PROJECT: SYMPHONY PARK AT UNION PARK, PARCEL M-3

CITY OF LAS VEGAS		DATE:
INTER-OFFICE MEMORANDUM		May 9, 2011
TO: Land Development Services Department of Public Works		FROM: Albert Sung, P.E. Flood Control Project Engineer Department of Public Works
SUBJECT:	Drainage Study for:	
	Symphony Park at Union Park, Parcels M-1, M-2 & M-3	
Cross Streets:	Symphony Park Ave. & Promenade Place	
File Number:	F:\Depot\DSMemos\DS4527B.doc	
Parcel Number:	139-34-211-001; 139-33-511-009 & -010	
Zoning Action:	SDR-41033	
FEMA Flood Zone	YES	NO X
Proposed Storm Drain	YES	NO X
COPIES TO:		Martin & Martin Civil Engineers
		City Parkway V Inc.
		Bart Anderson, P.E., DevCo

ADDENDUM #1 TO TECHNICAL DRAINAGE STUDY Update for Symphony Park

**RE: Addendum I to The Technical Drainage Study
Symphony Park at Union Park, Parcels M1, M2 & M3
DS #4527A
Martin & Martin Project Number: 3119**

CANOPY/ENCROACHMENT EXHIBIT

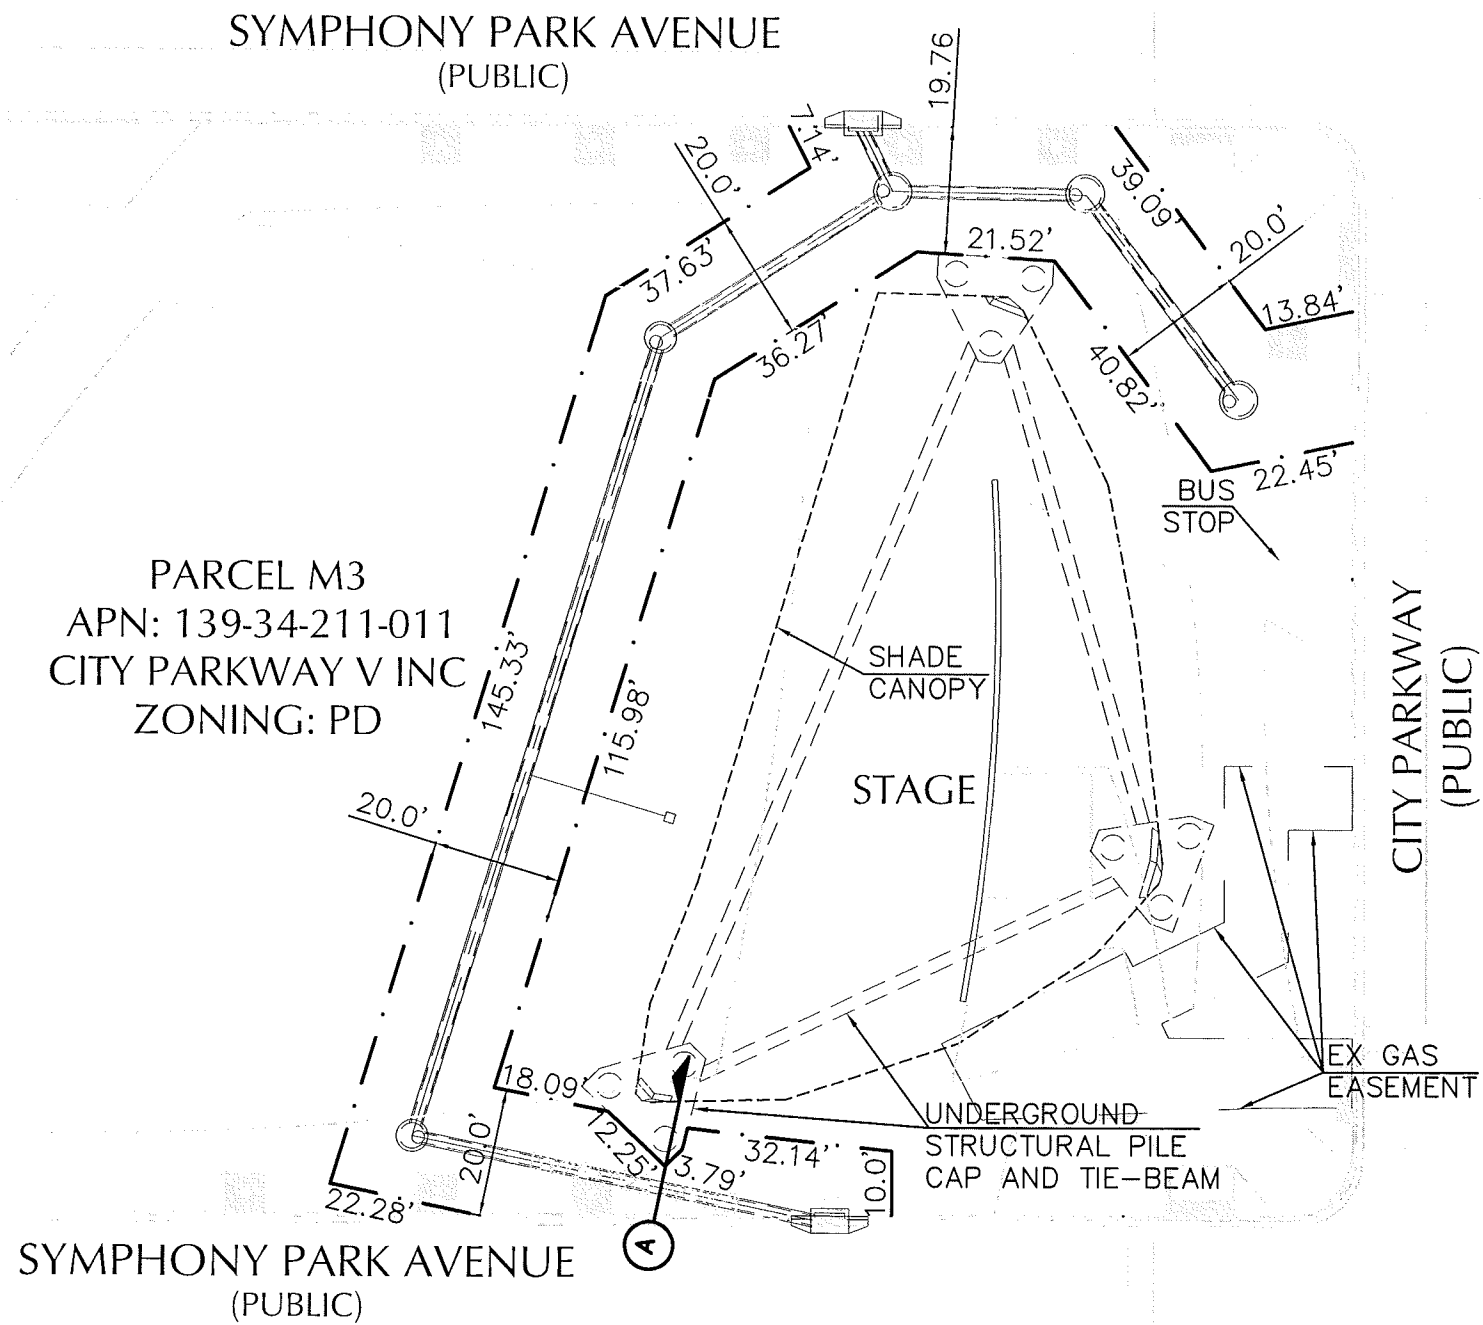
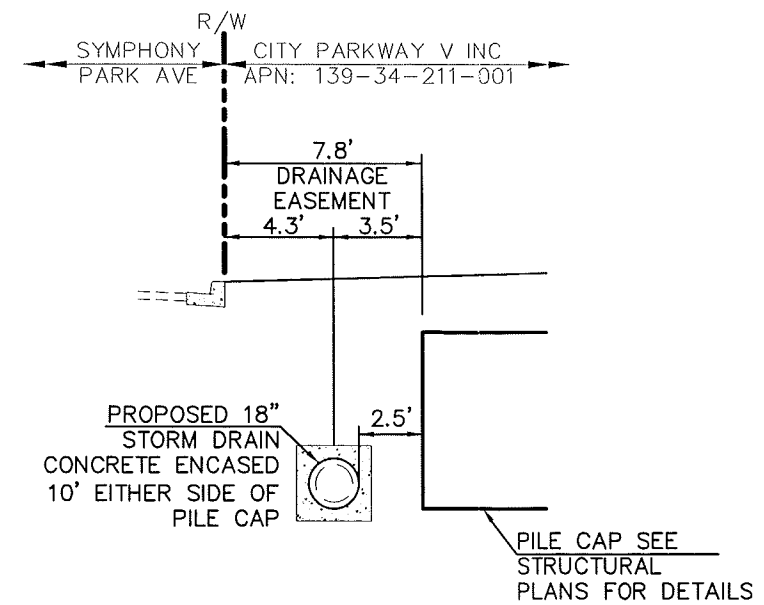
- Comment 5 Sheet C4.02: Provide a 20'-wide public drainage easement (privately maintained) centered to the proposed onsite storm drain system. The easement must be granted and recorded by separate document prior to the final acceptance of improvement plans.

- Response 5 **A 20' wide public drainage easement (privately maintained) will be provided except for a small section where a pile cap is to be located. Please see cross section J on Sheet C8.01 and Canopy/Encroachment Exhibit.**
